Access Compliance Report

Public Rights-of-Way

(Curb Ramps)

Intersection ID: 3742	Main Street: GALLOWAY_RD	Cross Street: TRADITION_VIEW_DR	Location: E
ADA ID: FB4A98720EF4	Ramp Type: Perp	Initial Pass/Fail: Fail	Overall Compliance: No
Severity Score: 10			
Codes/Mitigation Info/Possible Solution		Field Measurements/Component Compliance

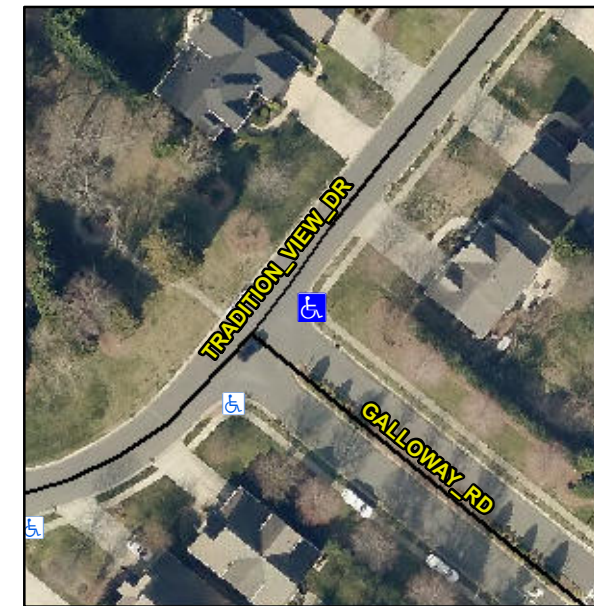
Not Found, R304.5.1, R304.5.3

Compliance	Description	Data	Compliance	Description	Data
N/A	Ramp Length (in)	47.0	Yes	Ramp Slope (%)	5.5
No	Ramp Width (in)	45.5	No	Ramp XSlope (%)	2.8
N/A	Flare Type LT	N/A	N/A	Flare Type RT	N/A
N/A	Flare Slope LT (%)	N/A	N/A	Flare Slope RT (%)	N/A
N/A	Flare Traversable LT?	N/A	N/A	Flare Traversable RT?	N/A
N/A	Landing Length (in)	N/A	N/A	DWS Provided?	N/A
N/A	Landing Width (in)	N/A	N/A	DWS Contrast?	N/A
N/A	Landing Slope (%)	N/A	N/A	DWS Length (in)	N/A
N/A	Landing X Slope (%)	N/A	N/A	DWS Full Width?	N/A
N/A	Landing Curb? (Y/N)	N/A	N/A	DWS Offset (in)	N/A
N/A	Shared Landing?	N/A			
N/A	Gutter Ponding?	N/A	N/A	Gutter Slope (%)	N/A
N/A	Gutter Lip Ht (in)	1.0	N/A	Gutter X Slope (%)	N/A
N/A	Painted X Walk1?	No	N/A	Painted X Walk2?	N/A
	X Walk 1 Direction	To SW		X Walk 2 Direction	N/A
N/A	X Walk 1 Width (in)	N/A	N/A	X Walk 2 Width (in)	N/A
	X Walk 1 Slope (%)	5.1		X Walk 2 Slope (%)	N/A
	X Walk 1 X Slope (%)	0.9		X Walk 2 X Slope (%)	N/A

Remove & Replace Entire Ramp.
